**City of Lake Elmo Parks Commission
3800 Laverne Avenue North
July 18, 2022 6:30 PM**

TO: Parks Commission
FROM: Ben Hetzel, City Planner & Molly Just, Planning Director
AGENDA ITEM: Schiltgen East Preliminary PUD and Plat

To: Molly Just, Planning Director
Cc: Marty Powers, Public Works Director
Chad Isakson, Assistant City Engineer
From: Jack Griffin, P.E., City Engineer
Re: Schiltgen East
Preliminary Plat/Plan Review

OVERALL SITE PLAN

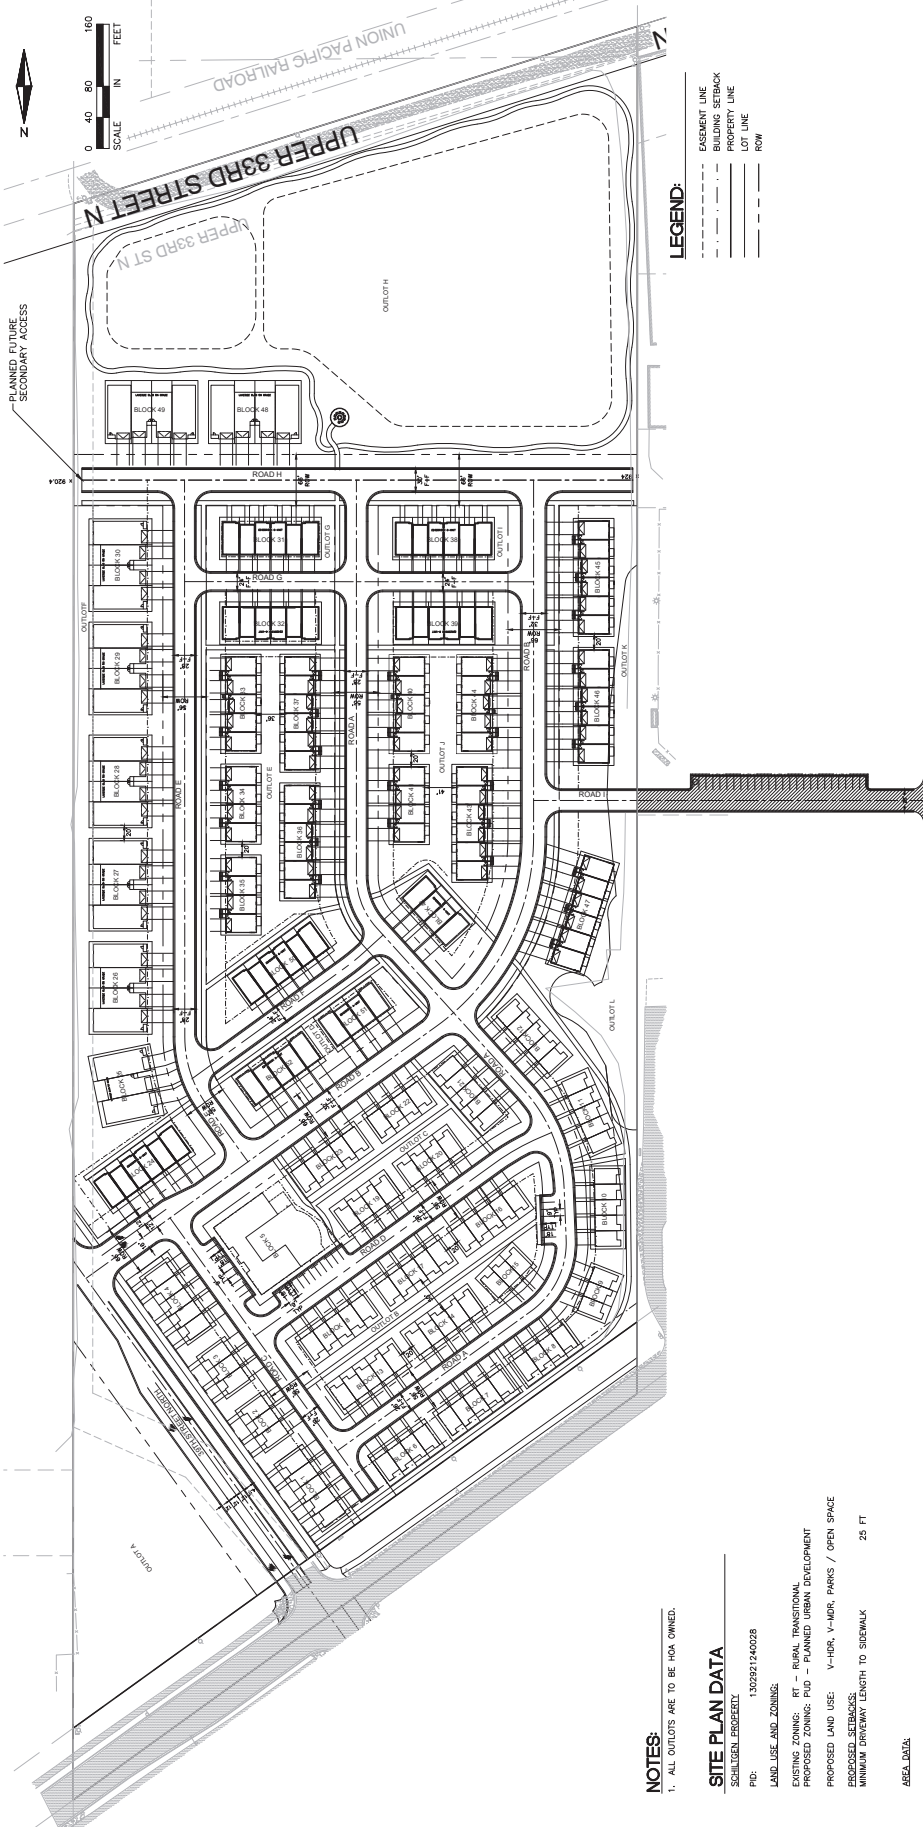
STATUS/FINDINGS: Engineering recommends denial of the Preliminary Plat as presented. Should be applicant desire to continue to move forward with development of the property it is recommended that the plans be significantly revised to be in compliance with the secondary access requirements and City Design Standards dated January 2022. In particular the proposed preliminary plat fails to provide adequate public right-of-way, adequate public streets, and the application provided an incomplete grading and storm water management plan. Engineering believes that once these items are corrected, the preliminary plan will contain significant revisions.

1. Revise the preliminary plat/plans to provide the required 10-foot dedicated drainage and utility easements along all public right-of-way. All required easements are missing from the preliminary plat documents.
2. Revise right-of-way width for Road A, C, D, and E to meet city minimum required 60 feet.
3. Provide dedicated minimum 60-foot right-of-way for Roads F and G, or remove proposed public watermain and public sanitary sewer from within the private roadway corridors.
4. Provide dedicated right-of-way/roadway easement for Road I on the preliminary plat/plans.

1. Revise the Site Plans to show all revised Preliminary Plat information identified above, including Outlots, Outlot ownership, minimum required right-of-way widths, all dedicated drainage and utility easements, and all off-site easements required to construct the proposed improvements.

6. Revise street width for Road A, C, and D to meet minimum required 28 feet (face of curb to face of curb).
7. Revise street width for Road H to meet minimum required 32 feet (face of curb to face of curb).
